Manuscript: amt-2023-106

Title: Aerosol properties derived from COCCON ground-based Fourier Transform spectra

Response to Referee#2

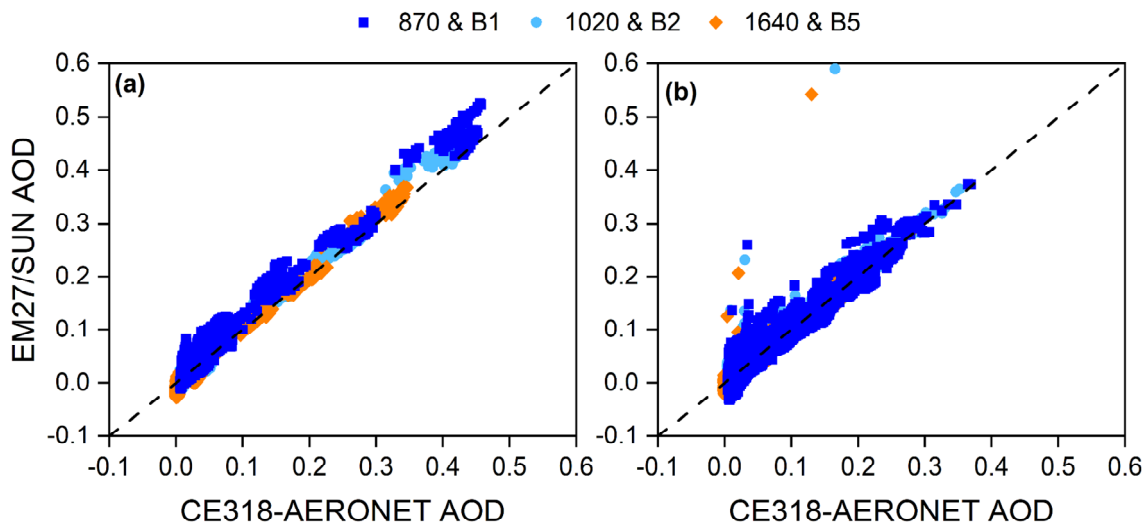
8. Figure 4:

8.1. please make two figures, one with 2019-2022 (whole period) and the other one with Dec 2019 - Dec 2020, with the open markers and the plain one, it is too confusing to interpret the graphic.

8.2. In the legend "open circles" -> "open markers" (there are other open symbols than circles)

Authors: The authors agree with this comment. A Figure 4 has been replaced by this figure:

Authors: This statement has been modified in the manuscript following the referee's suggestion.
